Track Standards Bulletin #008

August 30, 2022

Bulletin No. 008

Figure 19-A. Location of Permanent Transition Tie Sets

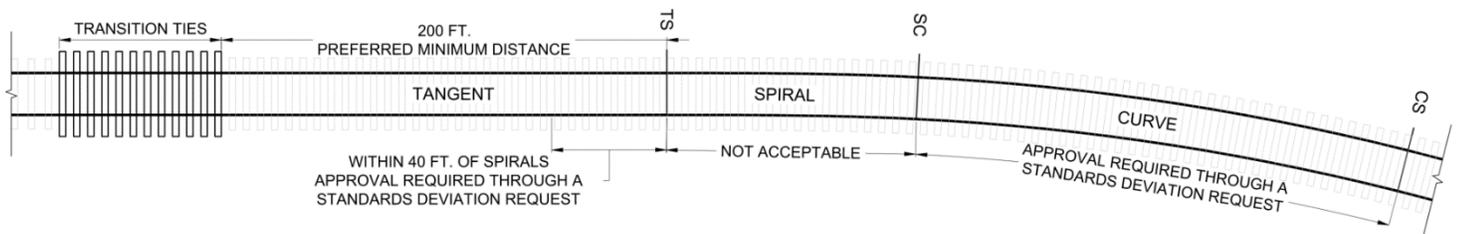
Refer to Section 9.2.9 and revise as follows:

9. Permanent transition tie sets shall not be placed within horizontal curves nor within spirals. The distance between transition tie sets and spirals (TS and ST geometry points) and simple curves (BC and EC) shall be the greater of:

Preferred minimum: 200 ft. (61.0m)

Absolute minimum: 40 ft. (12.20m)

Any values lower than 200 ft. (61.0m) must be reviewed and approved by Engineering & Asset Management - Track.

Installation of permanent transition tie sets within 40 ft. of spirals or in full body of curves must be reviewed and approved in writing through a Standards Deviation Request.

Figure 38-A. Destressing Length for Open Cut Culvert Installations

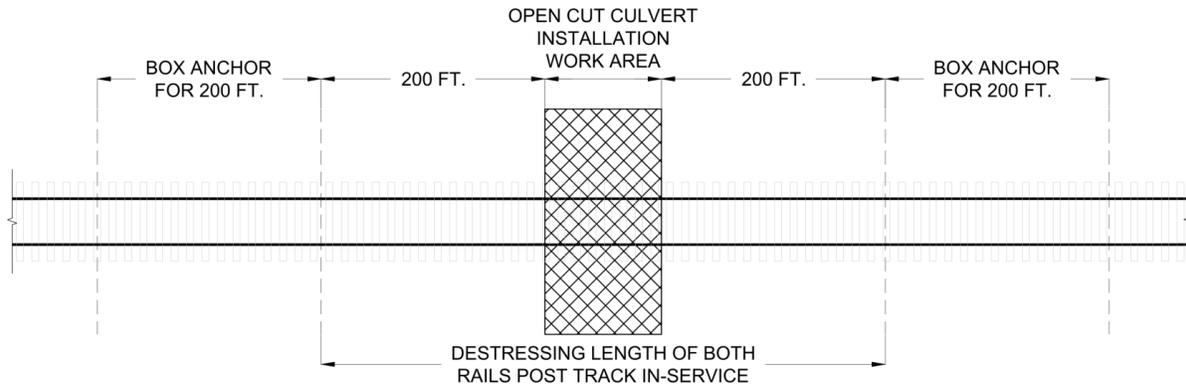
Refer to Section 21.4 and add:

22. When open cut or excavation/tie removal culvert installation methods are leveraged on timber tie trackage, both rails must be box anchored (every tie) for 200' commencing 200' from the work area in each direction. Destressing of both rails must be conducted post Track In-Service. This distance of the destressing limits shall encompass the work area, plus 200' in both directions.
